**PLANNING COMMISSION MEETING
THURSDAY, SEPTEMBER 18, 2025
(IN PERSON AND VIA WEBEX)
BLOOMINGTON CIVIC PLAZA – CITY COUNCIL CHAMBERS
1800 WEST OLD SHAKOPEE RD.
BLOOMINGTON, MN 55431
6:00 PM**

| Originator Planning | Item 1.1 City Fleet Maintenance Facility - FSBP - 1800 West 96th Street. |

In Case #PL2025-113, having been able to make the required findings, I move to approve Final Site and Building Plans to construct an approximately 40,000 square-foot City fleet maintenance facility located at 1800 West 96th Street, subject to the conditions and Code requirements attached to the staff report.

L1-1
LANDSCAPE
PLAN

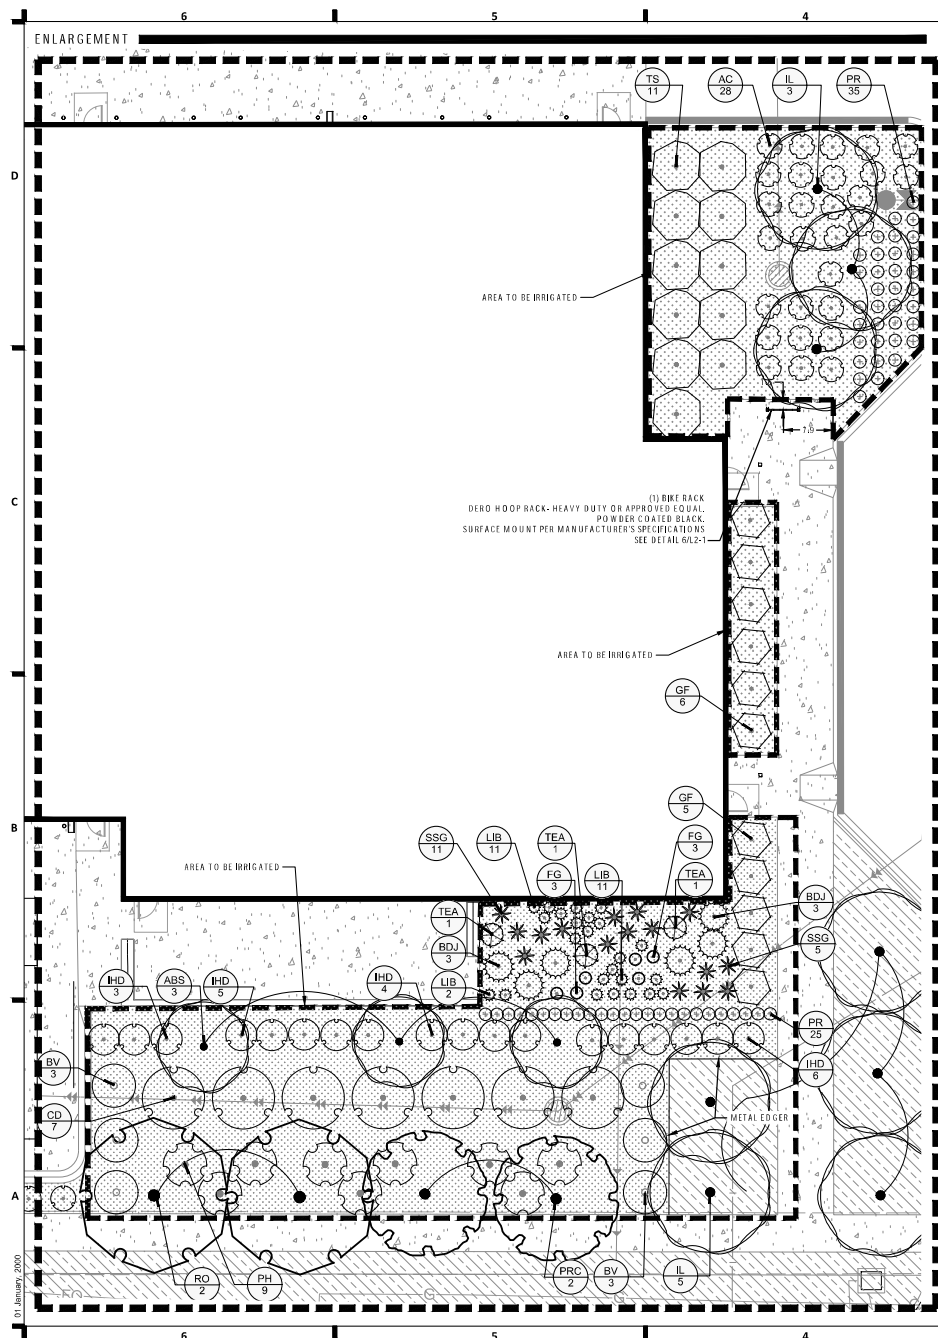
The proposed landscaping plan meets most applicable requirements, which include a minimum of one tree per 2,500 square feet and one shrub per 1,000 square feet of developable landscaped area. For parking lots with more than 50 spaces, each parking island must contain at least one

tree. Compliance with this standard will be required prior to issuance of the parking lot permit, and the landscaping plan must be revised to clearly indicate trees within the parking lot islands.

The Civil Plans do not currently show the full 20-foot landscaping yard required along W. 96th Street. To comply with this requirement, the proposed surmountable curbs will need to be pushed back approximately seven feet, and the area may not be paved with concrete. Additional landscaping must be installed between the sidewalk and parking areas within the minimum 20-foot landscape yard. A condition has been included in the staff report requiring that this correction be made prior to permit issuance.

3. Prior to Permit Landscape plan must be approved by the Planning Manager (see § 21.301.15).
4. Prior to Permit All trash and recyclable materials must be stored inside a fully enclosed building matching the building materials of the primary building. See §21.301.17

1 ELECTRICAL SITE PHOTOMETRIC PLAN - INITIAL
SCALE: 1" = 30'-0"

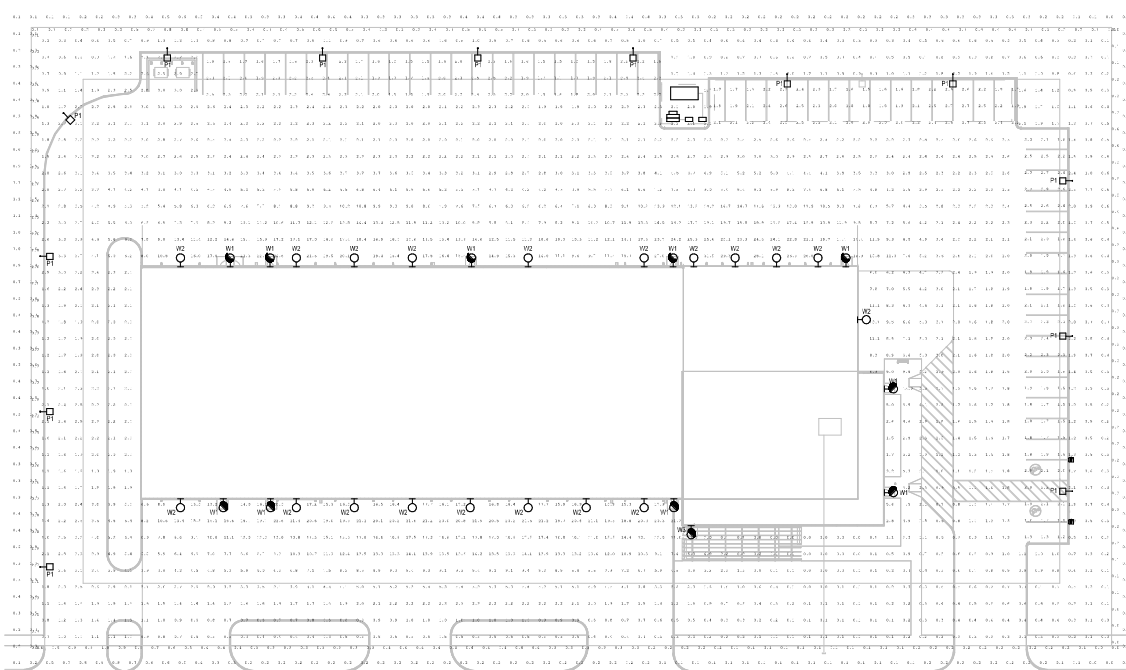
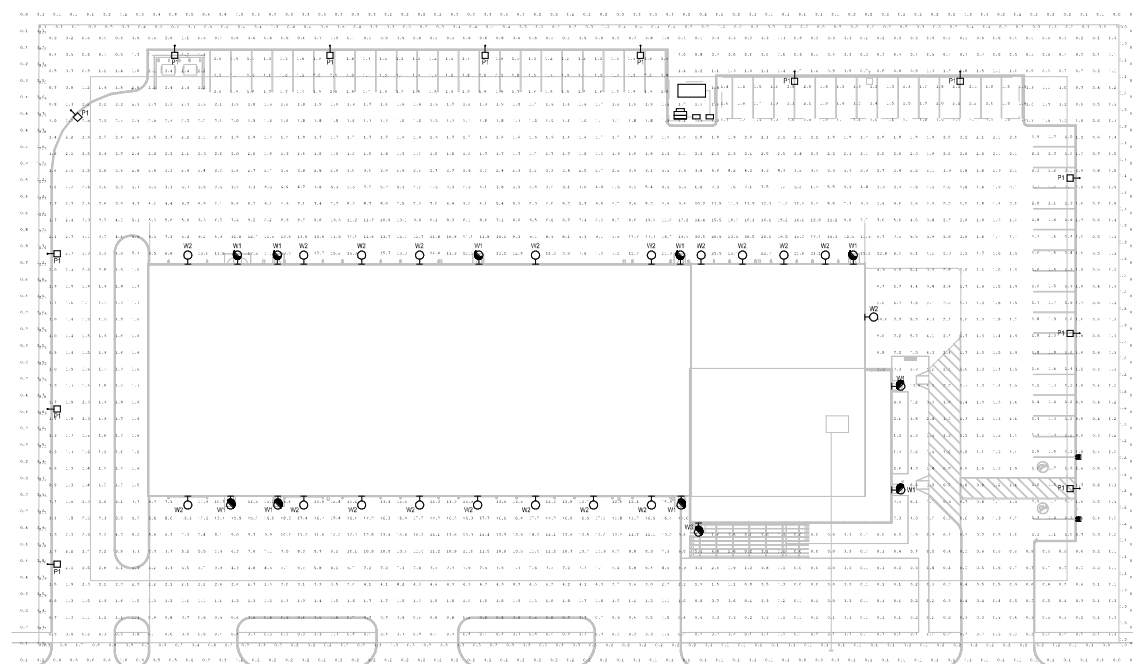
The submitted lighting plan does not meet the required minimum of 1.5 foot-candles across the parking area. For the outer perimeter of the lot, the standard is reduced to a minimum of 0.75 foot-candles. Additionally, a minimum of 7.0 foot-candles is required at all primary entrances and exits. A condition has been added to the staff report to ensure compliance with these lighting standards prior to permit issuance.

1. Prior to Permit Sewer Availability Charges (SAC) must be satisfied.
2. Prior to Permit Parking lot and site security lighting plans must satisfy the minimum requirements. See §21.301.07.

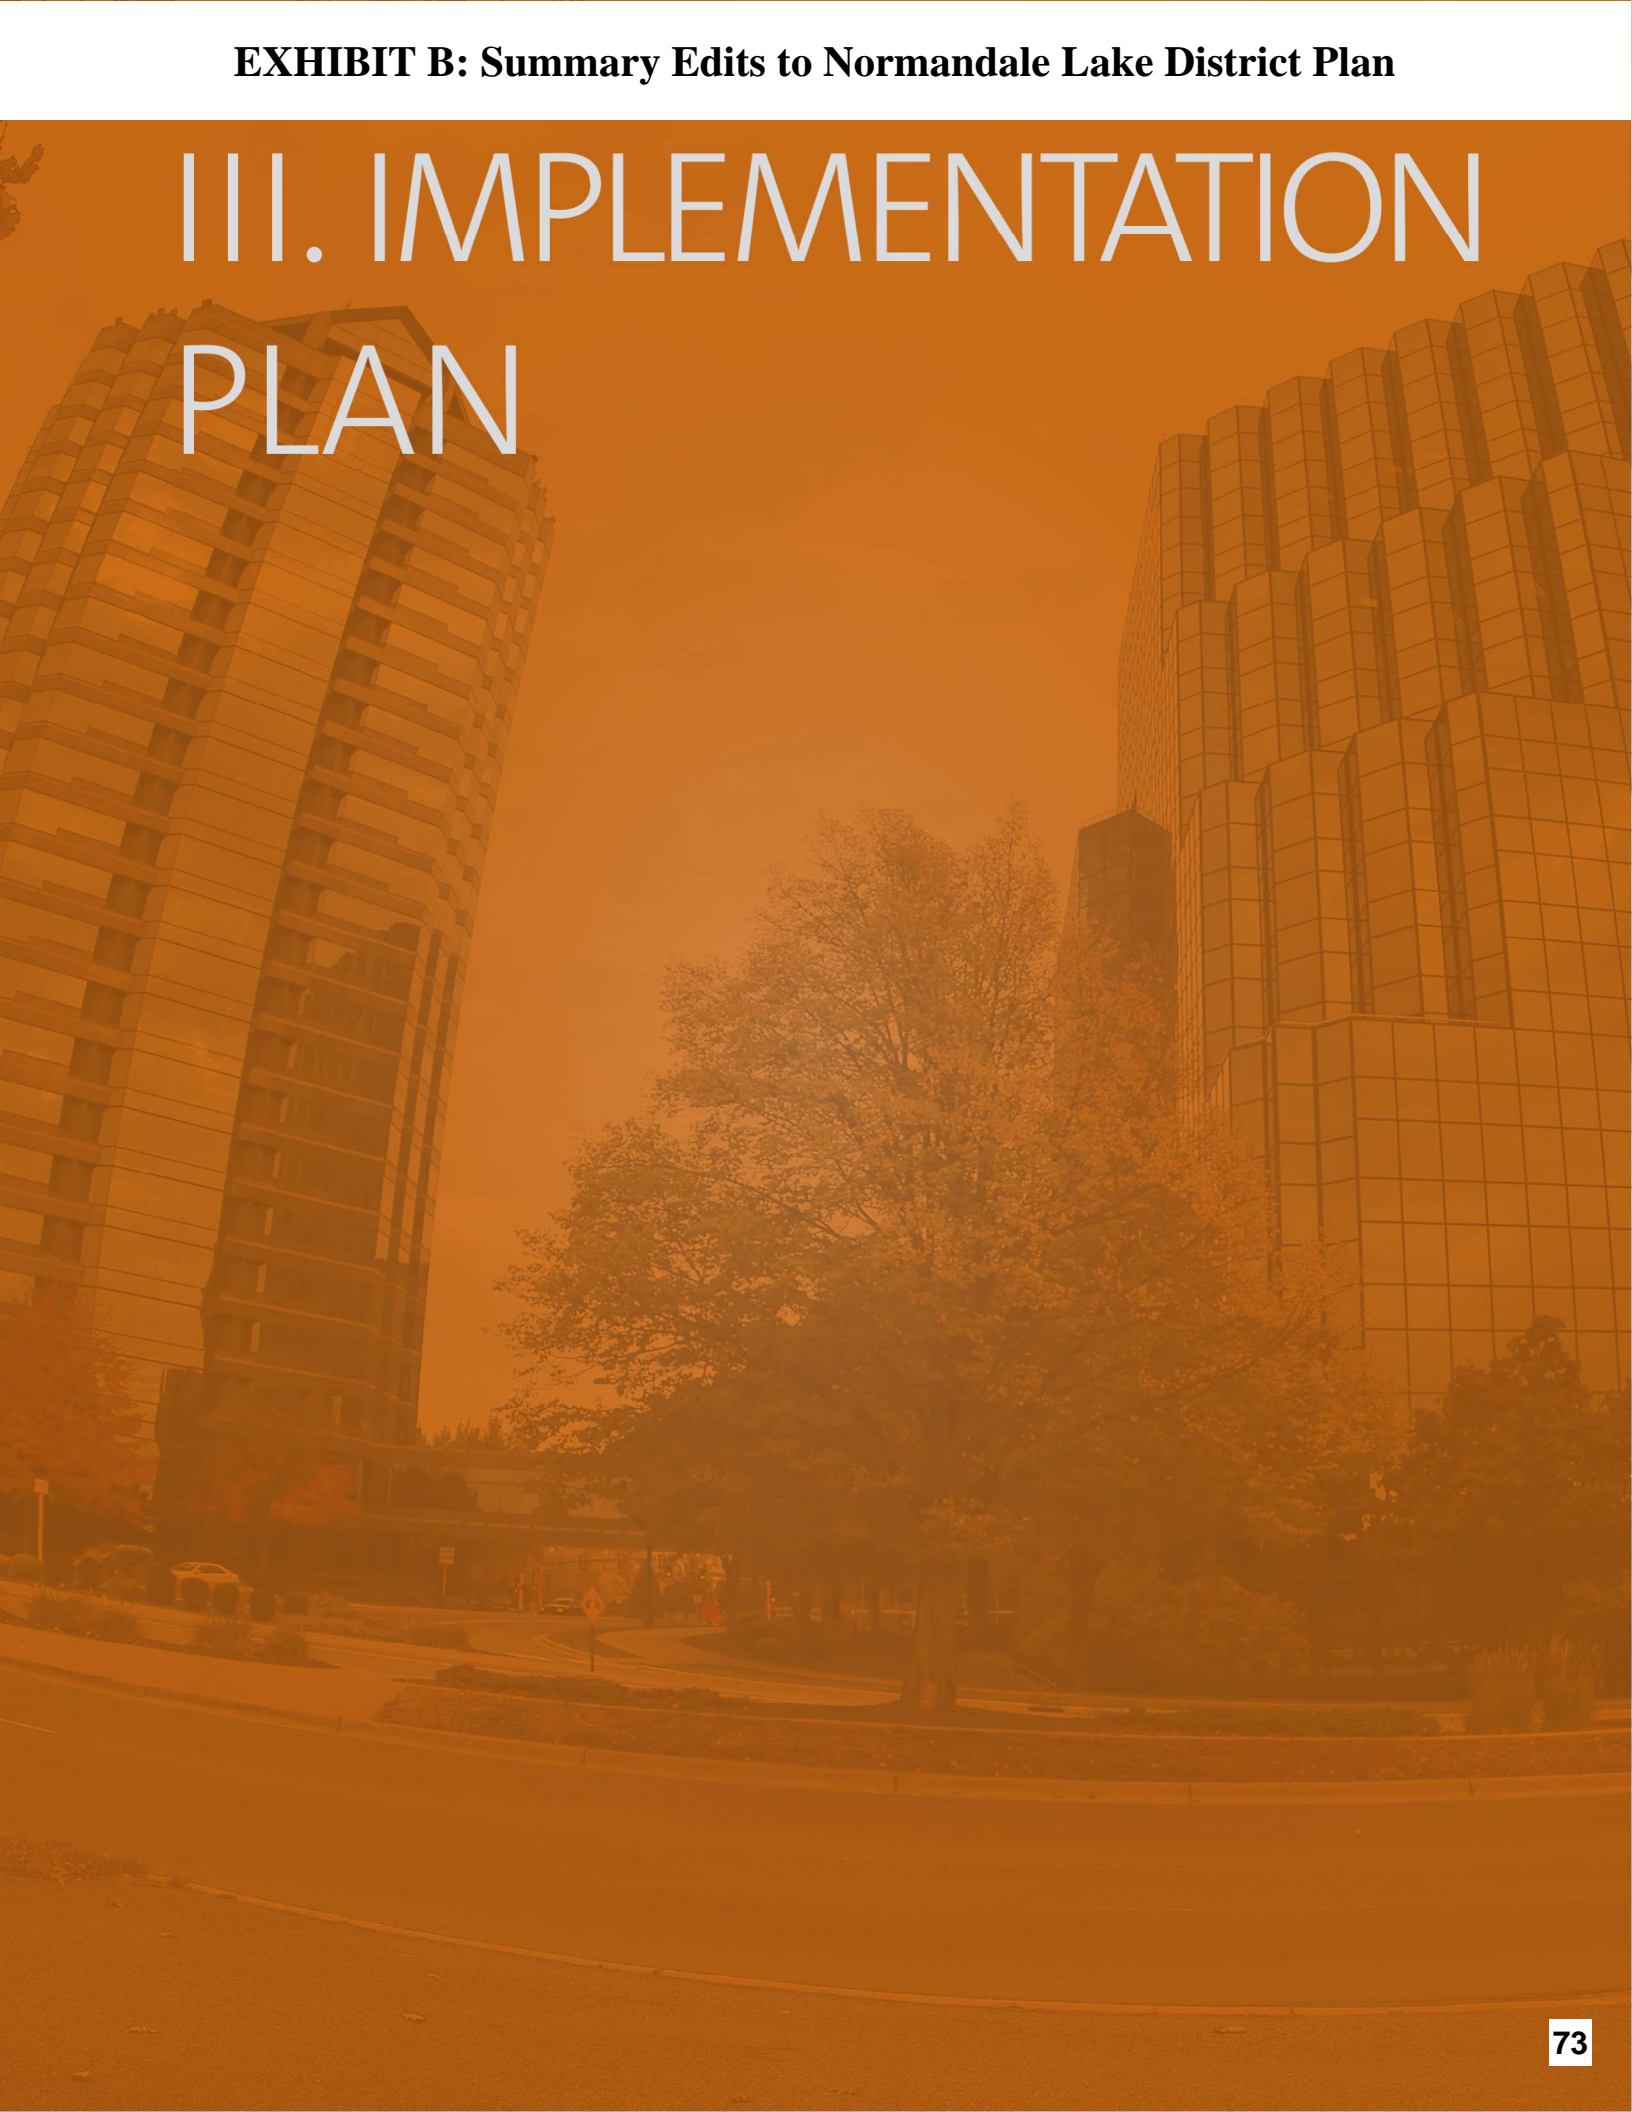
Remove pedestrian bridge from list of future projects

Figure 13: Regional Bicycle Route Connection

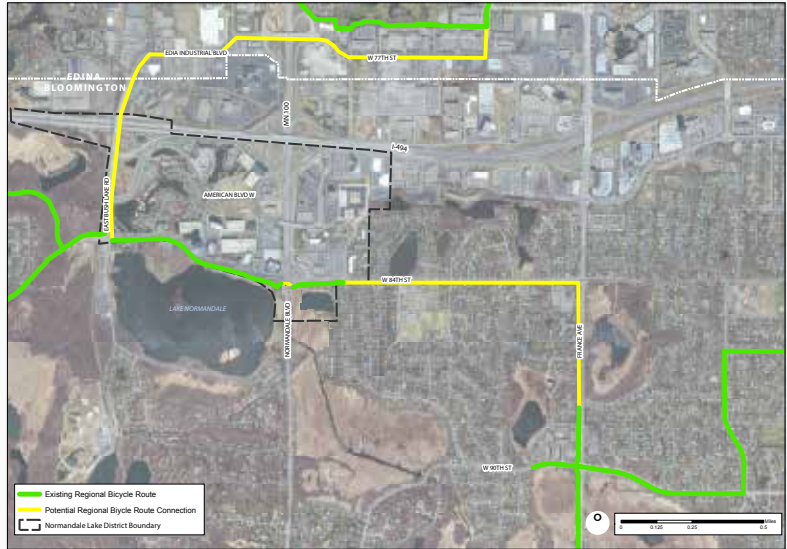
Update Figure 13 to remove reference to “Potential Pedestrian Bridge”
